# BOILER SAFETY REPORT

## Masihata Sweaters Ltd (Extension)

**Factory ID:** 24617

| **FINDING NO:** | B-6 |   |

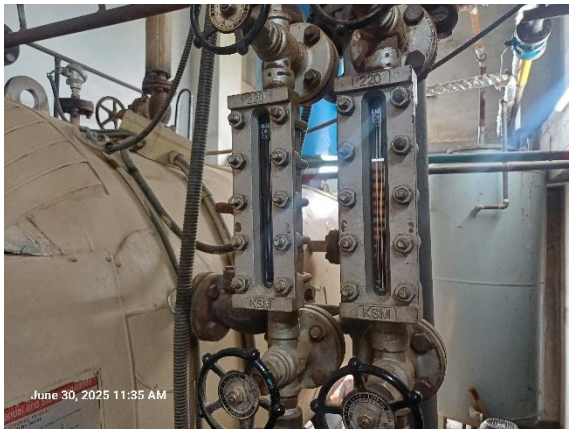
| **FINDING:**<br>Low Low Water Level (LLWL) was not marked properly on water level gauge glass system. | | |

| **RECOMMENDATION:**<br>The Low Low Water Level (LLWL) should be marked beside the gauge glass on a separate arrangement so that the water level can be visualized and identified clearly. | | |

| **FINDING NO:** | B-7 |   |

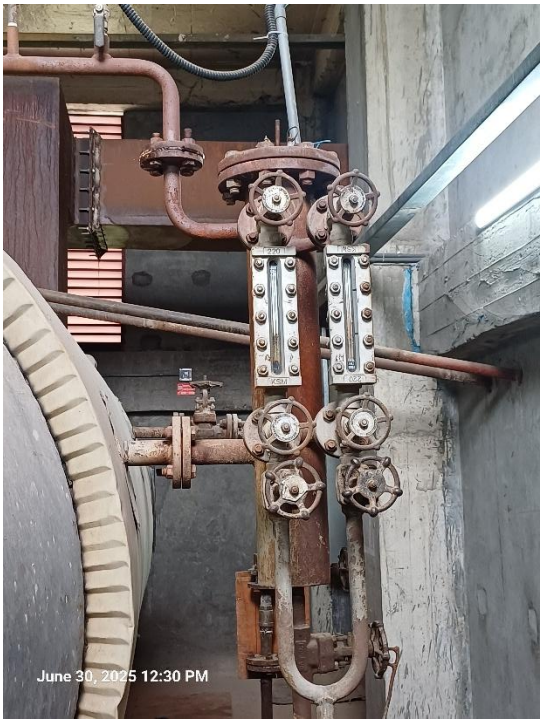
| **FINDING:**<br>Low Low Water Level (LLWL) was not marked properly on water level gauge glass system. | | |

| **RECOMMENDATION:**<br>The Low Low Water Level (LLWL) should be marked beside the gauge glass on a separate arrangement so that the water level can be visualized and identified clearly. | | |

| **FINDING NO:** | B-8 |

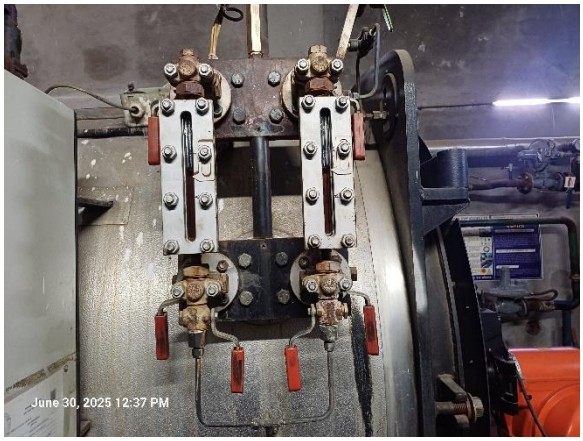
| **FINDING:**<br><br>Low Low Water Level (LLWL) was not marked properly on water level gauge glass system. | |

| **RECOMMENDATION:**<br><br>The Low Low Water Level (LLWL) should be marked beside the gauge glass on a separate arrangement so that the water level can be visualized and identified clearly. | |

| **FINDING NO:** | B-10 |

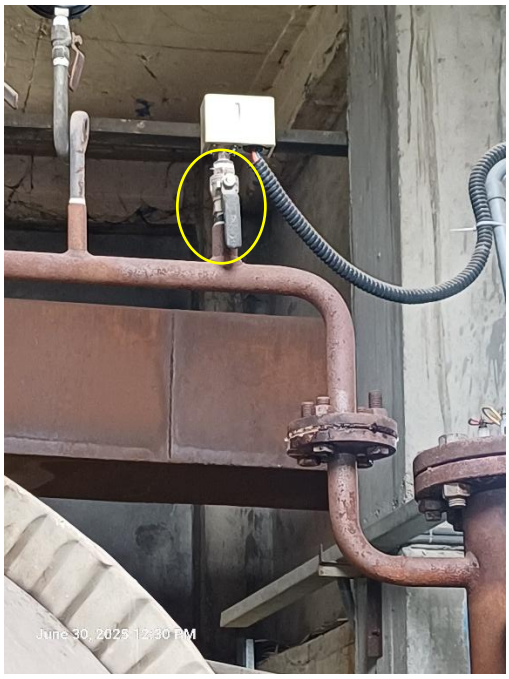
| **FINDING:**<br><br>Valves were observed between the boiler and the pressure controller. | |

| **RECOMMENDATION:**<br><br>The measuring and sensing devices related to boiler safety shall be mounted directly with the boiler without any valves in between. | |

| **FINDING NO:** | B-15 |

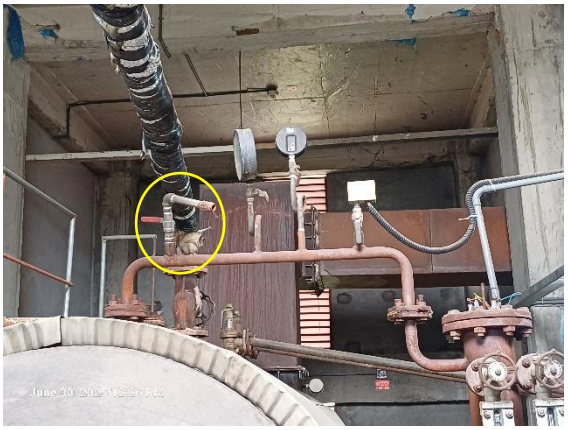
| **FINDING:**<br><br>The boiler air vent line was not directed to the outside of the boiler room. | |

| **RECOMMENDATION:**<br><br>The boiler vent line should be directed outside of the boiler room with proper support. | |

| **FINDING NO:** | B-21 |

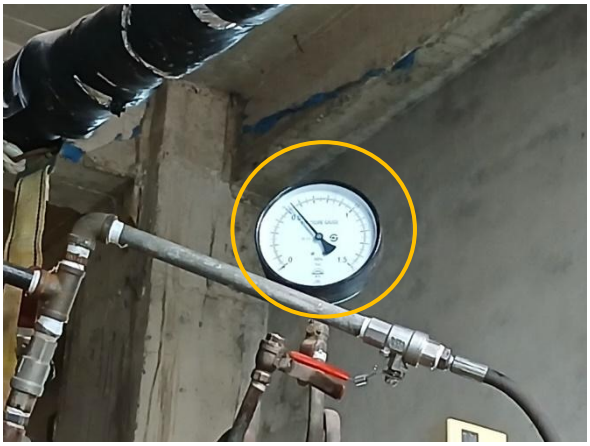
| **FINDING:**<br><br>The steam pressure gauge range was insufficient. | |

| **RECOMMENDATION:**<br><br>The boiler pressure gauge range should be at least twice the boiler's maximum allowable working pressure mentioned in the boiler license or in accordance with any recognized international standard. | |

| **FINDING NO:** | B-23 |

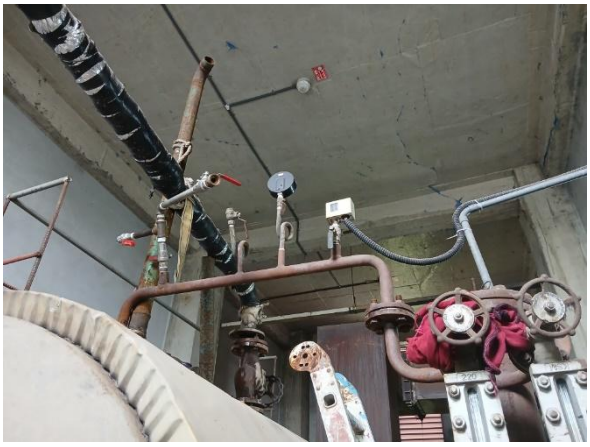
| **FINDING:**<br><br>Boiler exhaust gas pipeline inside the boiler room was found with improper insulation. | |

| **RECOMMENDATION:**<br><br>Proper insulation to boiler exhaust gas pipeline inside the boiler room causing heat exposure for personnel shall be provided. | |

| **FINDING NO:** | B-28 |

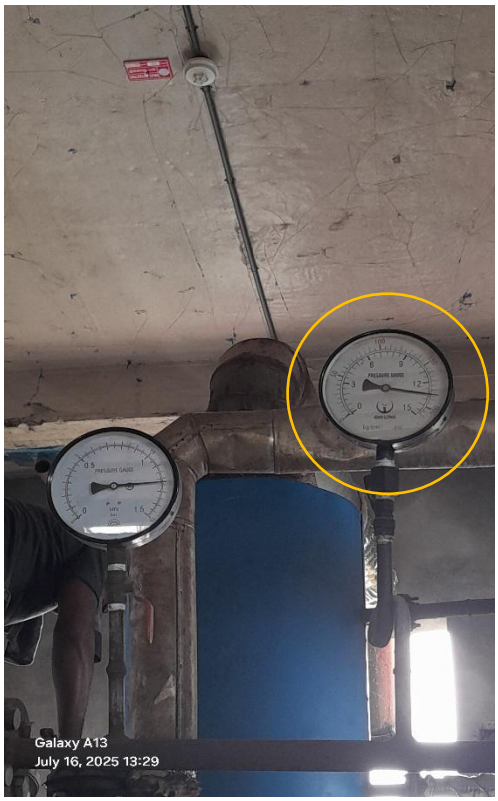
| **FINDING:**<br><br>An inconsistency was observed between the readings of the boiler pressure gauge and the calibrated pressure gauge. | |

| **RECOMMENDATION:**<br><br>Defective pressure gauge(s) shall be replaced with functional gauge(s) as per Bangladesh Boiler Regulation (BBR). | |

| **FINDING NO:** | B-29 |  |

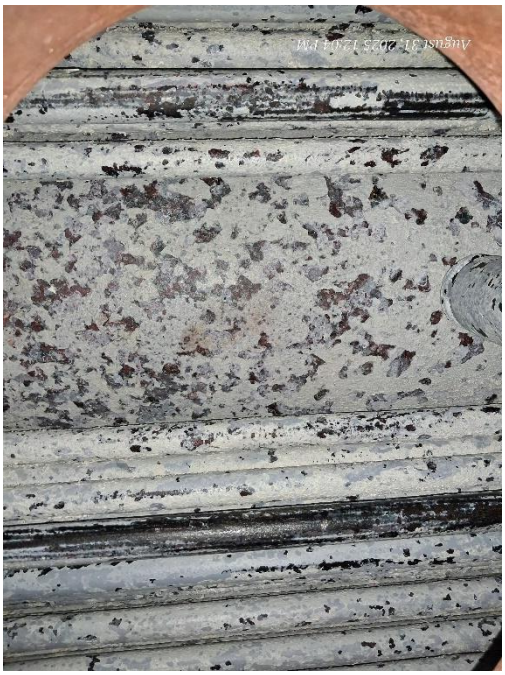
| **FINDING:**<br><br>Salt and scale (hard & medium) formation was observed on the waterside. | | |

| **RECOMMENDATION:**<br><br>Cleaning is required. A water treatment station is to be used. Feed and boiler water quality and conditioning should be verified and monitored. The boiler operator should operate the boiler with proper blowdown. | | |
